Groundwater and Wastewater Services File Imaging Project

Re: Permit Application for New Water Supply Well Installation
1415 Tom Hunter Road
Tax Parcel # 089-064-31
File # 6205B

ARGU Review Worksheet

EPIC Report for ARGU Review
1415 Tom Hunter Road, Charlotte
Tax Parcel ID #089-064-31
File # 6205B

ARGU Review FILE 6205B 1415 Tom Hunter Road

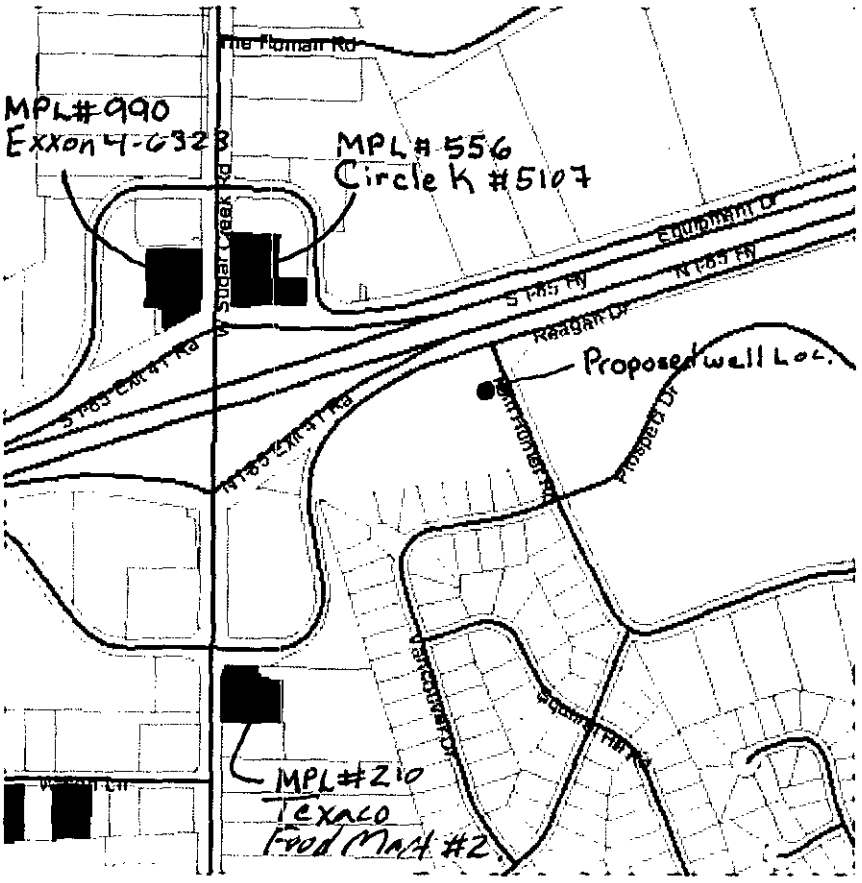
Proposed well site property is within 1000 feet of all of these sites. See well exclusion area on map in file. The entire property falls within 1000 feet of MPL#5107 Circle K #5107.

If the criteria of source area is used per b. then only a very small SE Corner of the property is suitable per regulation (see map in file).

Based on this review this permit application is denied per Mecklenburg County Groundwater Well Regulations Chapter VII Section (IV)(A)1. "Areas of Regulated Groundwater Usage, Requirements for New Water Supply Wells Within an Area of Regulated Groundwater Usage Paragraph (A) that reads:
